# Access Compliance Report

## Public Rights-of-Way

### (Curb Ramps)

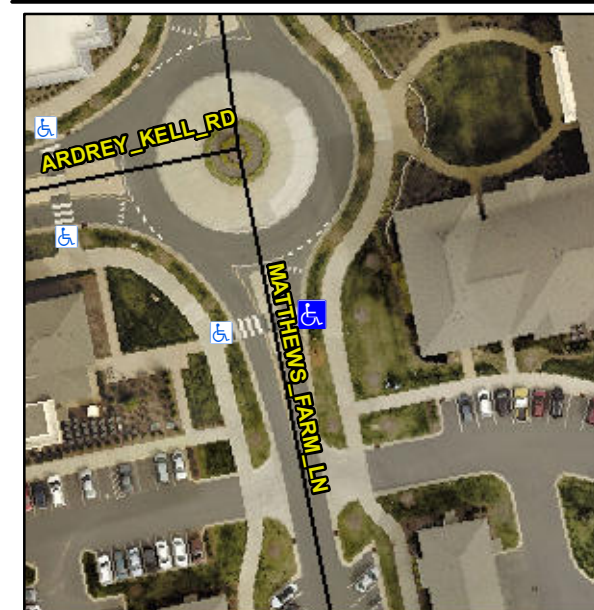
Intersection ID: 53421	Main Street: MATTHEWS_FARM_LN	Cross Street: ARDREY_KELL_RD	Location: SE
ADA ID: 8F1546243AD9	Ramp Type: Perp	Initial Pass/Fail: Fail	Overall Compliance: No
		Severity Score: 12.5	
Codes/Mitigation Info/Possible Solution		Field Measurements/Component Compliance

Compliance	Description	Data	Compliance	Description	Data
N/A	Ramp Length (in)	96.0	No	Ramp Slope (%)	8.7
Yes	Ramp Width (in)	119.0	Yes	Ramp XSlope (%)	0.3
N/A	Flare Type LT	N/A	N/A	Flare Type RT	N/A
N/A	Flare Slope LT (%)	N/A	N/A	Flare Slope RT (%)	N/A
N/A	Flare Traversable LT?	N/A	N/A	Flare Traversable RT?	N/A
N/A	Landing Length (in)	N/A	N/A	DWS Provided?	N/A
N/A	Landing Width (in)	N/A	N/A	DWS Contrast?	N/A
N/A	Landing Slope (%)	N/A	N/A	DWS Length (in)	N/A
N/A	Landing X Slope (%)	N/A	N/A	DWS Full Width?	N/A
N/A	Landing Curb? (Y/N)	N/A	N/A	DWS Offset (in)	N/A
N/A	Shared Landing?	N/A			
N/A	Gutter Ponding?	N/A	N/A	Gutter Slope (%)	N/A
N/A	Gutter Lip Ht (in)	N/A	N/A	Gutter X Slope (%)	N/A
N/A	Painted X Walk1?	Yes	N/A	Painted X Walk2?	N/A
	X Walk 1 Direction	To W		X Walk 2 Direction	N/A
N/A	X Walk 1 Width (in)	121.0	N/A	X Walk 2 Width (in)	N/A
	X Walk 1 Slope (%)	3.0		X Walk 2 Slope (%)	N/A
	X Walk 1 X Slope (%)	2.2		X Walk 2 X Slope (%)	N/A

**Remove & Replace Entire Ramp.**
